Flight Procedures Cover Page	Task Action: P-NOTAM	Task Type: IAP	Estimated Chart Date: 05/14/2026	APWS Task ID: B2B147CBE0DC4830B0A6A3A5297D68C1	APWS Project ID: 70587871567444BBAA9C2557331A9092
Procedure: RNAV (GPS) RWY 1 ORIG-B		Enroute: NO	Specialist: Johnson, Timothy		Agreement Number:
Airport ID: 51J			Airport City: LAKE CITY		State: SC
Facility ID:	Facility Type:	Flight Inspection Remark Type:

RNAV (GPS) RWY 1
LAKE CITY MUNI CJ EVANS FLD (51J)

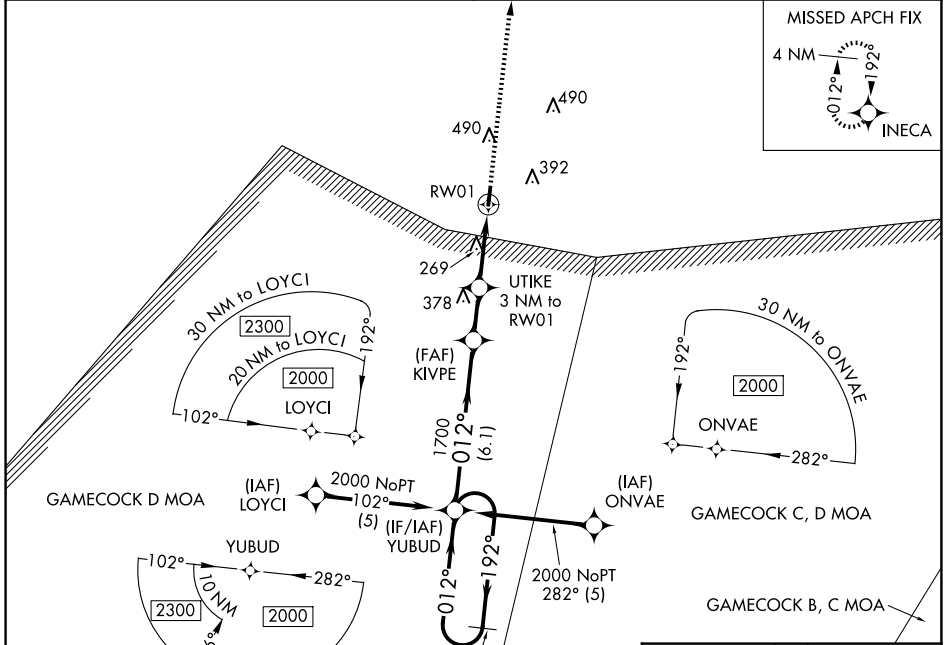
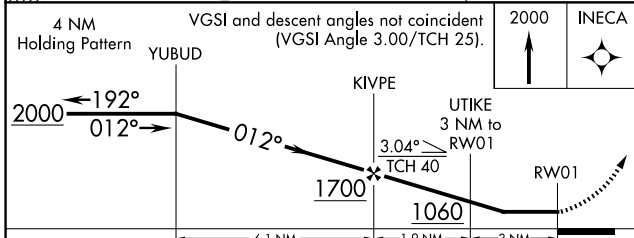
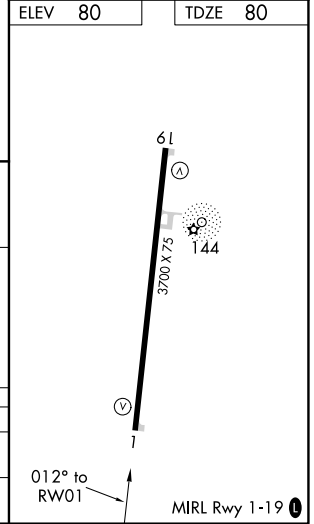
Visibility Initiative (Garmin) - Update IAP visibility minimums IAW Order 8260.3, Chapter 3, Section 3-3. Visibility Minimums.

CATEGORY	A	B	C	D
LNNAV MDA	560-1	480 (500-1)	560-1¼ 480 (500-1¼)	NA
CIRCLING	660-1 580 (600-1)	880-1 800 (800-1)	880-2¼ 800 (800-2¼)	NA
